## HISTORIC AND DESIGN REVIEW COMMISSION

May 02, 2018

**HDRC CASE NO:** 2018-182  
**ADDRESS:** 632 LEIGH ST  
**LEGAL DESCRIPTION:** NCB 2739 BLK LOT W 41.6 FT OF A19  
**ZONING:** R-5, H  
**CITY COUNCIL DIST.:** 1  
**DISTRICT:** Lavaca Historic District  
**APPLICANT:** Veronica Montemayor  
**OWNER:** Veronica Montemayor  
**TYPE OF WORK:** Construction of a two story, single family residential structure; installation of solar panels  
**APPLICATION RECEIVED:** April 13, 2018  
**60-DAY REVIEW:** June 12, 2018  
**REQUEST:**

1. Construct a two story, single family residential structure at 6332 Leigh Street, located within the Lavaca Historic District.
2. Install solar panels at the rear of the proposed new construction.

SITE PLAN  
 Scale 3/16" = 1'-0"

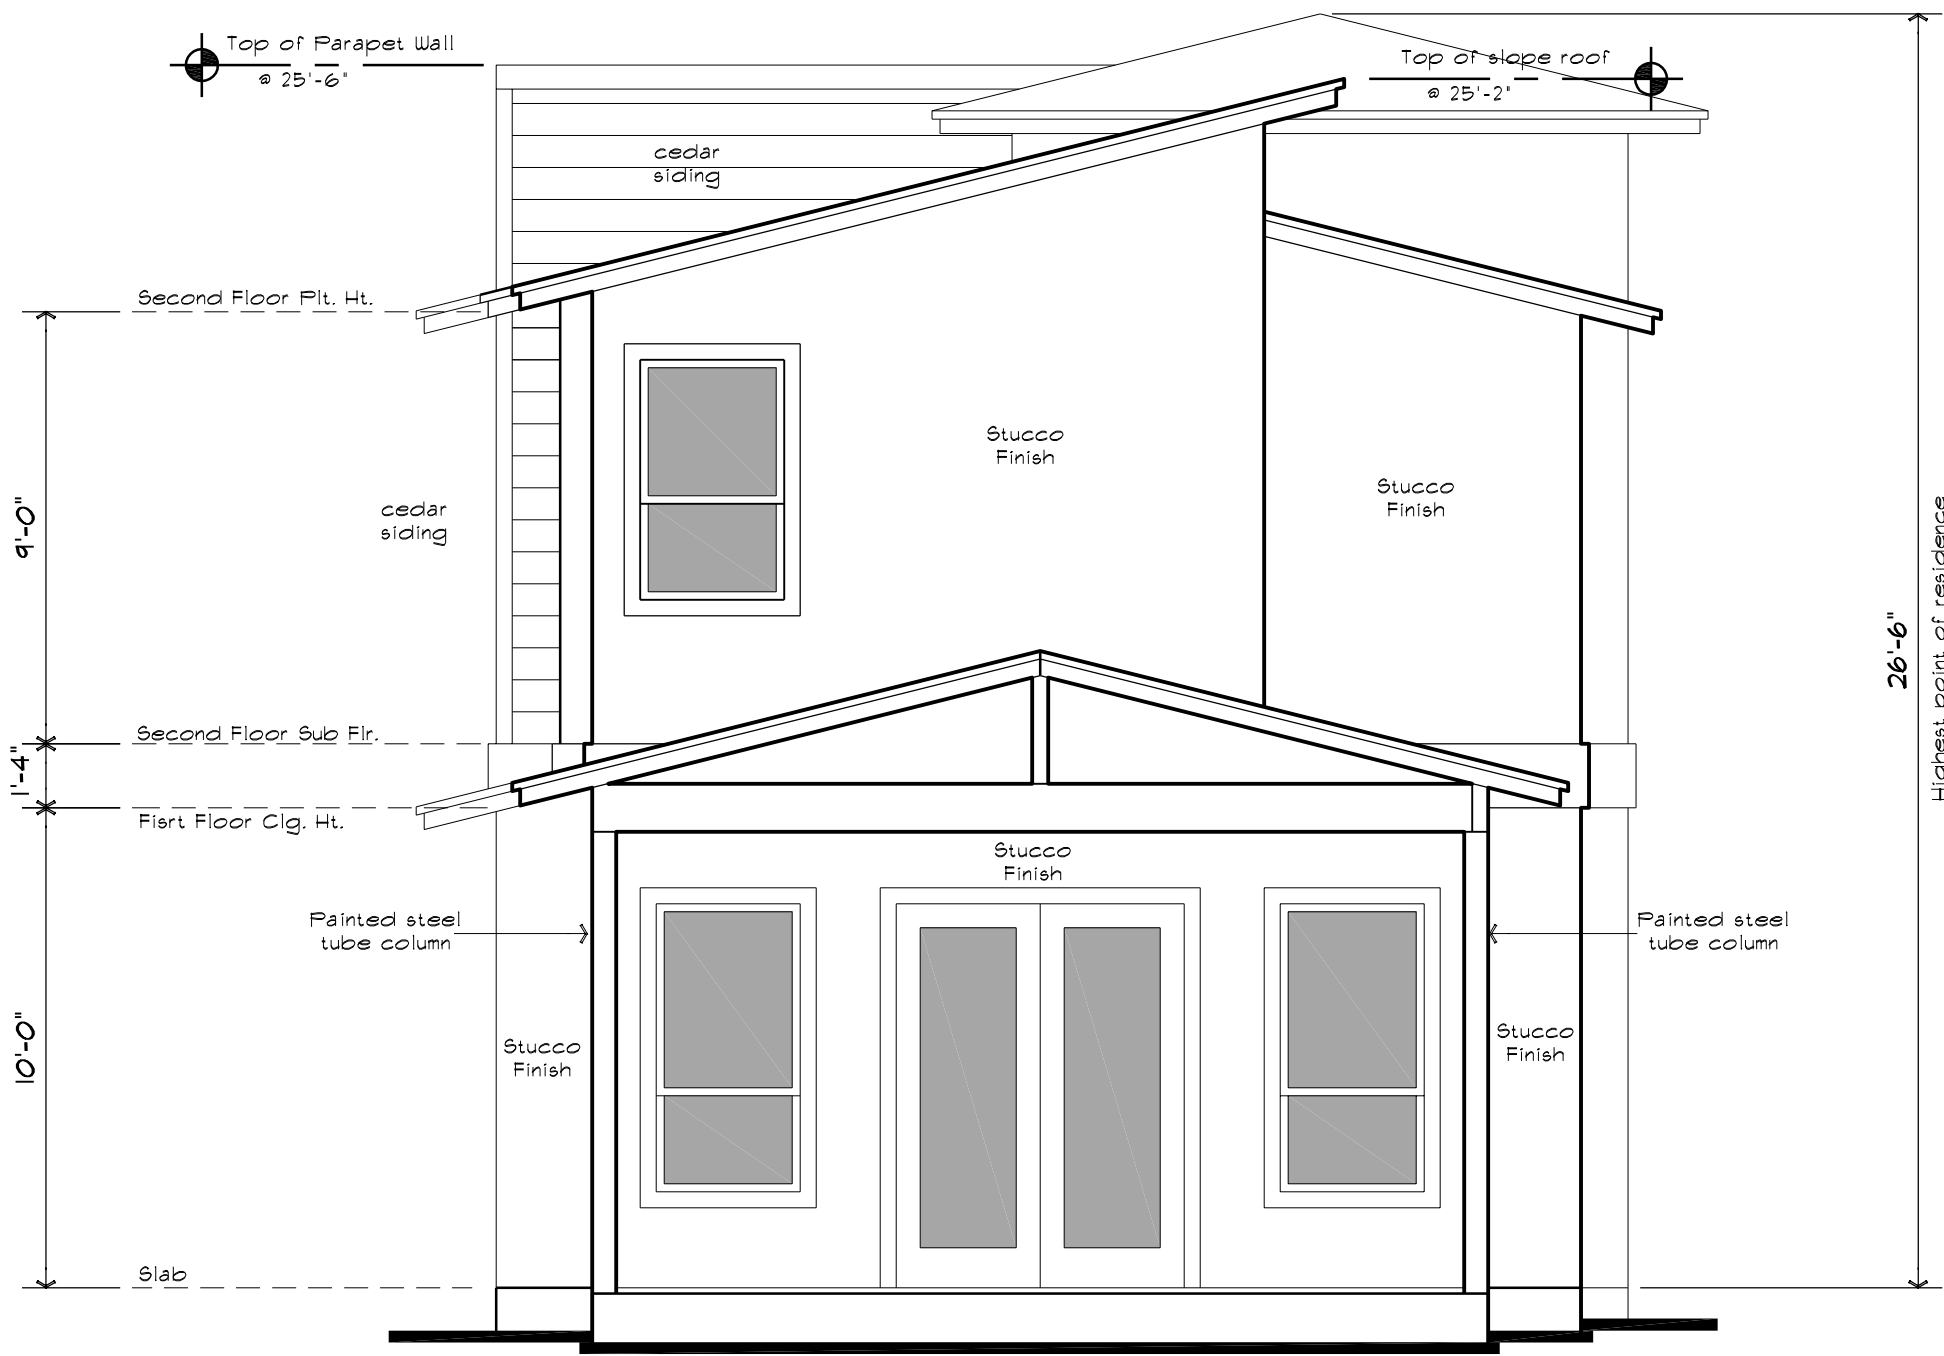
- k. **CARPORT & DRIVEWAY LOCATION** – The development pattern along Leigh includes side yard parking in driveways located on both the east and west sides of the primary structure. The applicant has proposed a curved driveway which terminates at the front façade of the proposed new construction, resulting in front yard parking and a carport on the front façade. This is not consistent with the development pattern found along the block. Additionally, front loading garages and front yard parking are not found historically within the Lavaca Historic District. Staff finds that the proposed parking location should be modified to be located in the side yard.

- v. That the proposed, front loaded carport and curved driveway be modified to not result in front yard parking as noted in finding k. The propose driveway should be straight and feature no more than ten (10) feet in width to match those found historically in the district.

REAR ELEVATION  
Scale 1/4" = 1'-0"

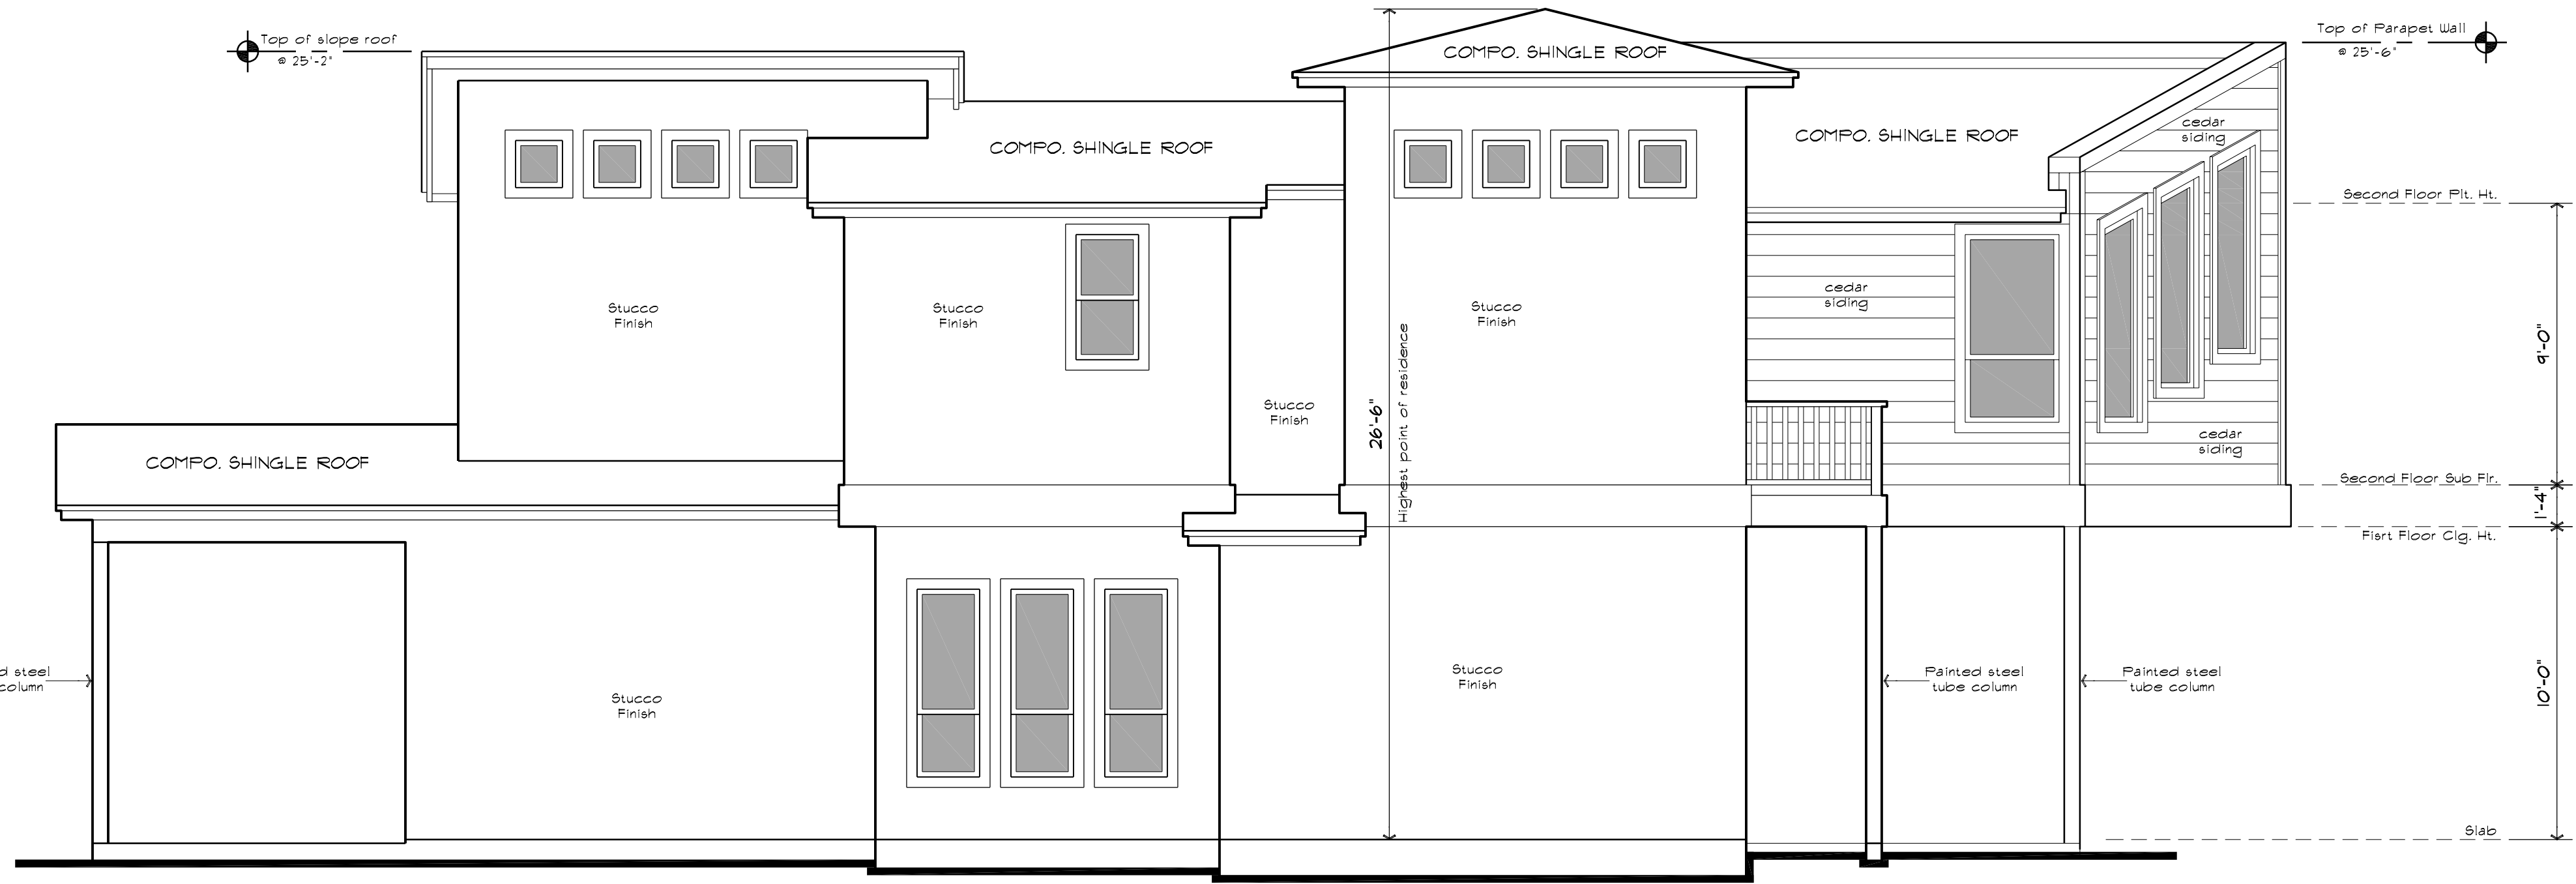
- m. SOLAR PANELS – The applicant has noted the installation of twenty-four (24) solar panels at the rear of the proposed new construction; however, has not specified the exact location or mounting pitch. Staff finds the installation of solar panels at the rear where not visible from the public right of way to be appropriate. The applicant is to provide a roof plan of the proposed locations of all solar panels to staff for review and approval prior to receiving a Certificate of Appropriateness for their installation.

- vii. That a roof plan be submitted to staff noting the location of the proposed solar panels as noted in finding m.

FRONT ELEVATION  
Scale 1/4" = 1'-0"

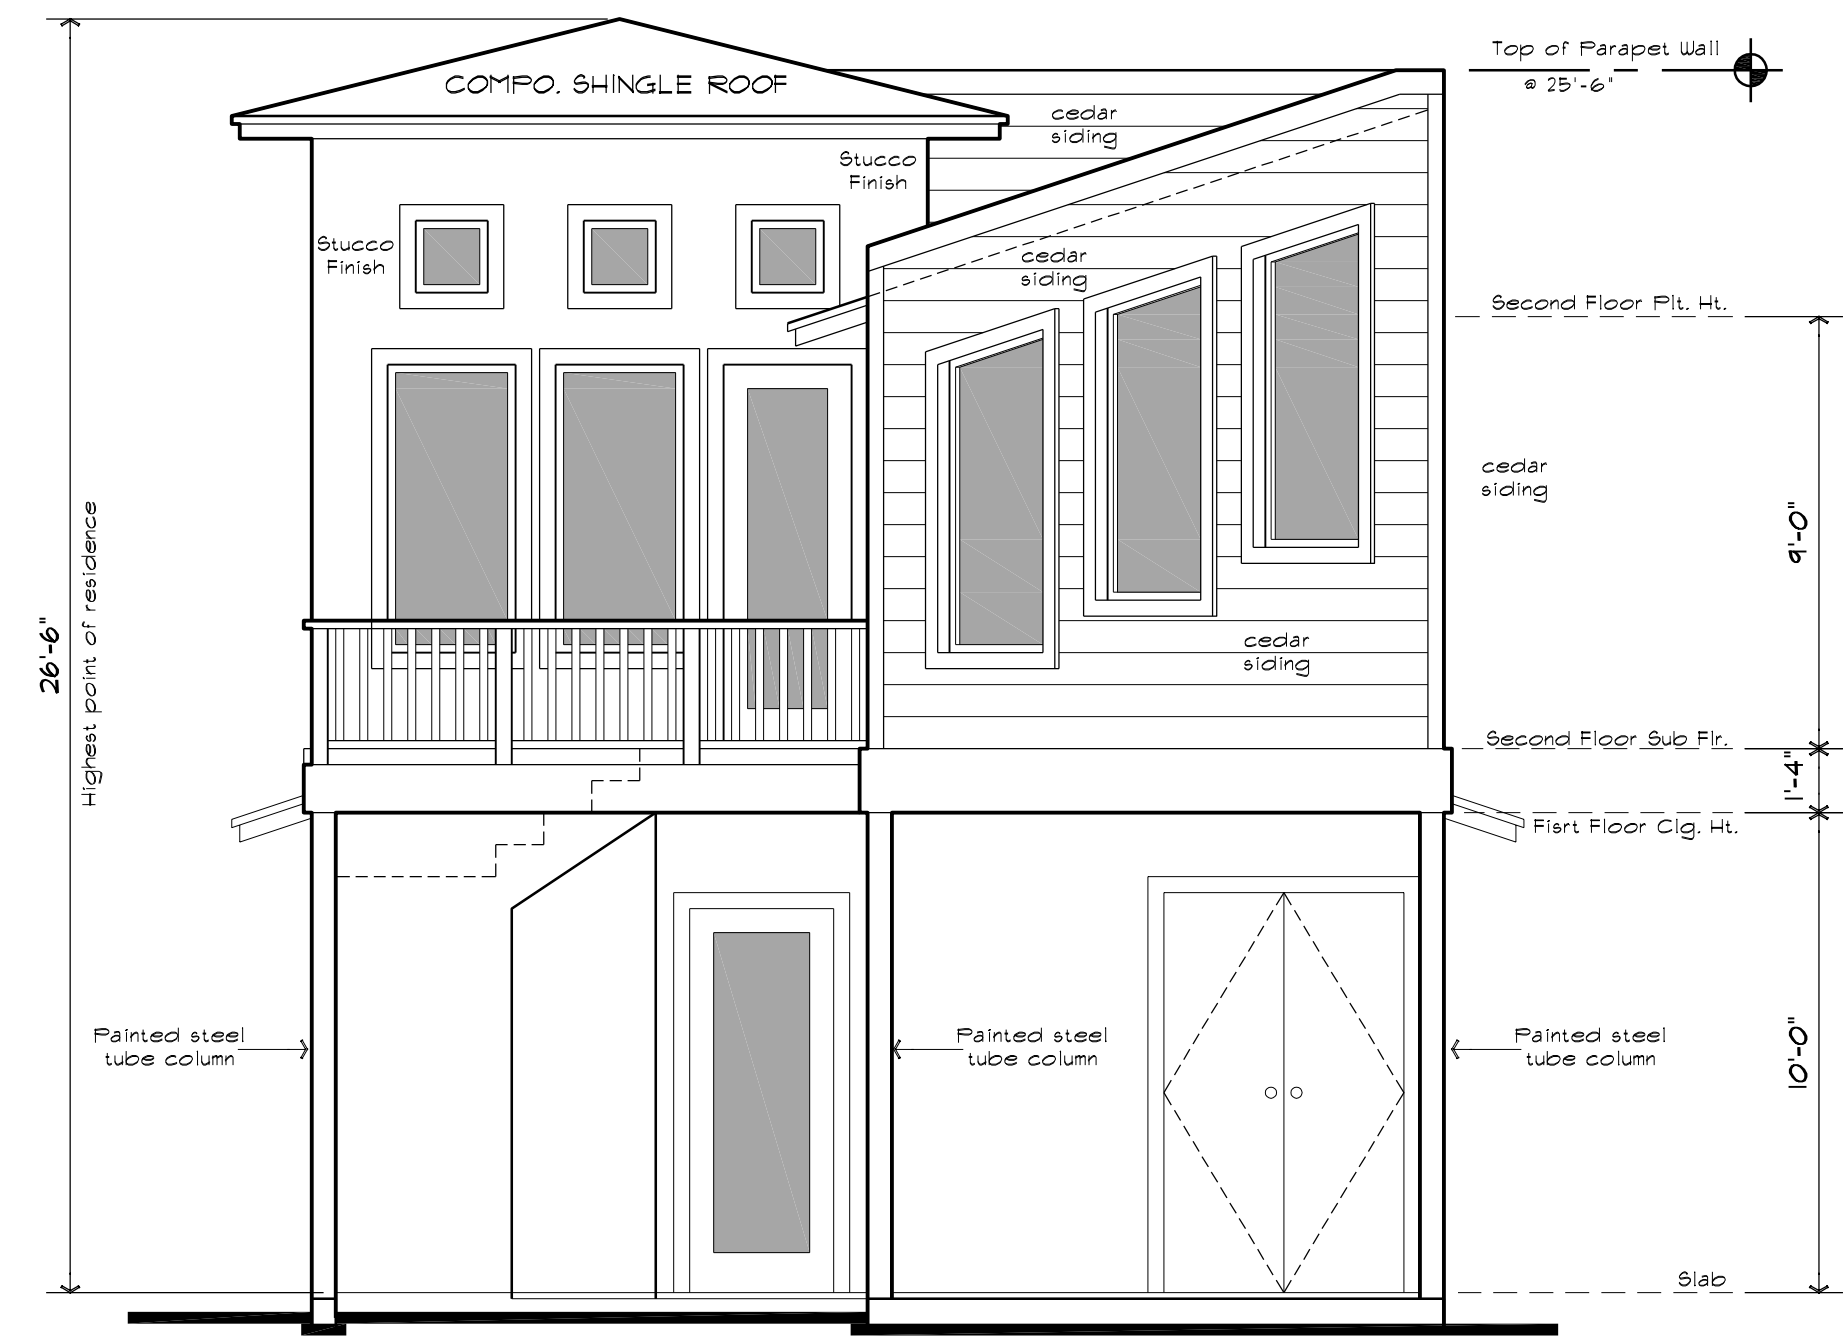
- f. **ROOF FORM** – The applicant has proposed roof forms that include shed, gabled and hipped roofs. The Guidelines for New Construction note that roof forms that are found historically in the district should be used. While the proposed forms are found historically in the district, they are not found in with the profile currently proposed. The proposed inward sloping shed roof on the front façade is inconsistent with forms found historically in the district. Staff finds that this form should be modified to feature a front facing gable, a form that is found consistently on front facades throughout the Lavaca Historic District.

- g. **WINDOW & DOOR OPENINGS** – Per the Guidelines for New Construction 2.C.i., window and door openings with similar proportions of wall to window space as typical with nearby historic facades should be incorporated into new construction. The applicant has proposed window openings that feature profiles that are not found historically in the district, including windows that feature a profile to match the proposed shed roof slope. Staff finds that window openings that feature proportions comparable to those found historically in the district should be used. The windows proposed on the rear elevation are comparable to those found historically in the district and should be implemented throughout the design. Additionally, double windows should be separated by a wood mullion rather than siding or abutting window trim.

- ii. That the applicant modify the proposed front shed roof to a roof form that is consistent with those found historically on the block, such as a front facing gabled roof as noted in finding f.

- iii. That the proposed window openings be consistent in size and profile with those proposed on the rear façade as noted in finding g. All windows grouped in groups of two should be separated by a mullion.

- vi. That the proposed contemporary architectural forms be modified to accommodate traditional elements that are found throughout the district such as a front facing gabled roof.
